Verification Report

GEO101021

McAlear & Rushe

Gas membrane to specification BS8485 2015

LOCATION/GRID LINE: H Block wall

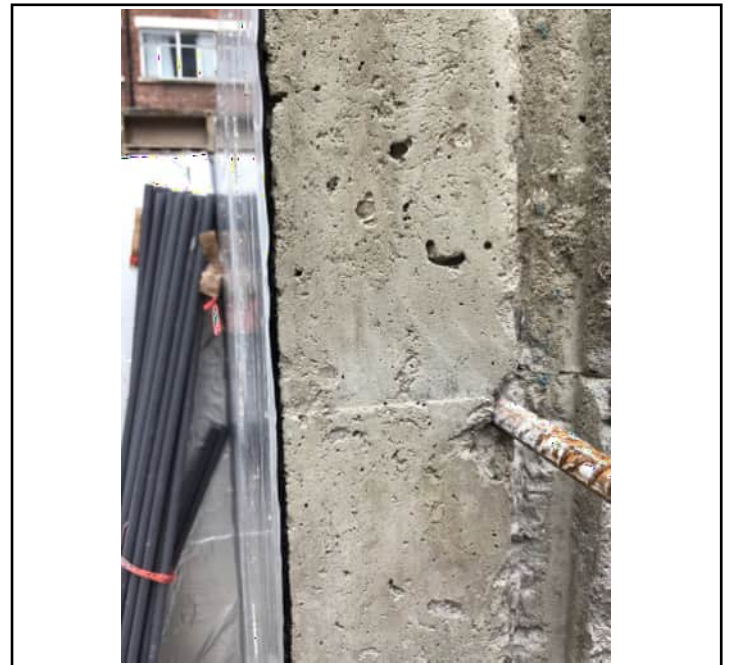
NOTES: The walls of H Block have been primed with bitumen and

GR SAM has been installed with a 300mm overlapped has been installed onto the

Concrete slab. A pick and probe test was carried out to ensure a good seal.

Left photo) GR SAM installed vertically with 300mm overlap on slab

Right photo) GR SAM sealed to concrete wall

Pile cap with Visqueen Geoseal

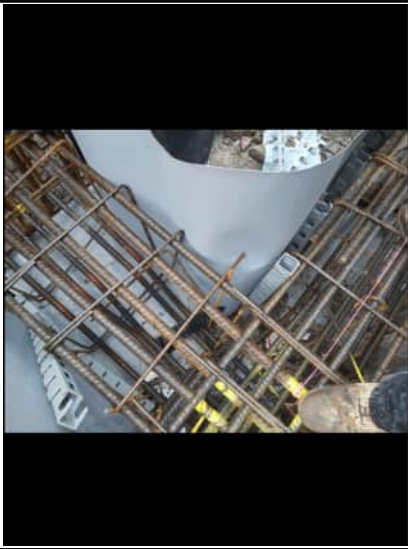
Ultimate
